REMARKS

DRAWING AMENDMENTS:

ANNOTATED MARKED-UP DRAWINGS

FIG. 1

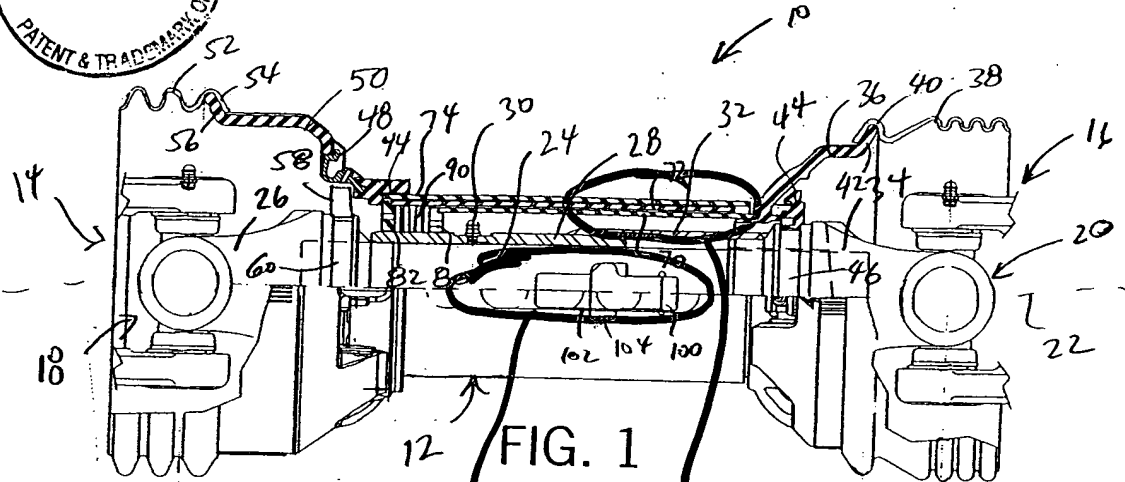
Regarding point 1f, Fig. 1 now shows the tab and slot arrangement of the claims in the same manner as Fig. 2, albeit when the guard is contracted.

clean up

Show
tab/slot
as in Fig. 2

Show w/
Correct X-hatching
and at increased
scale X 1.5 - X 2

FIG. 2

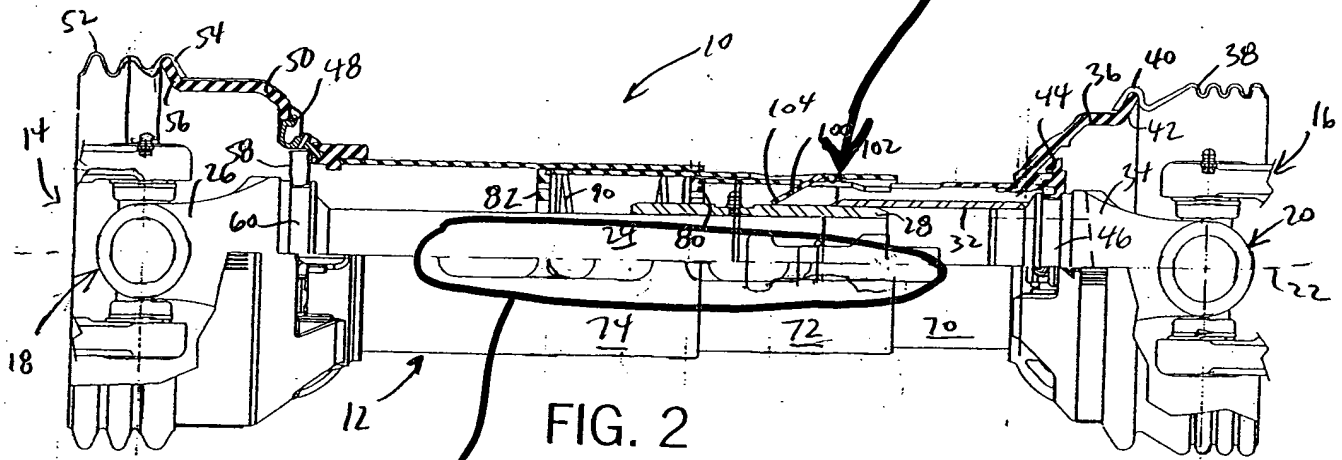
Regarding point 1d, the spring 90 is in fact shown in Fig. 2 biased against the end piece 82 as stated in the specification as represented by the vertical line just to the right of the vertical line defining the right side of the end piece.

Clean up
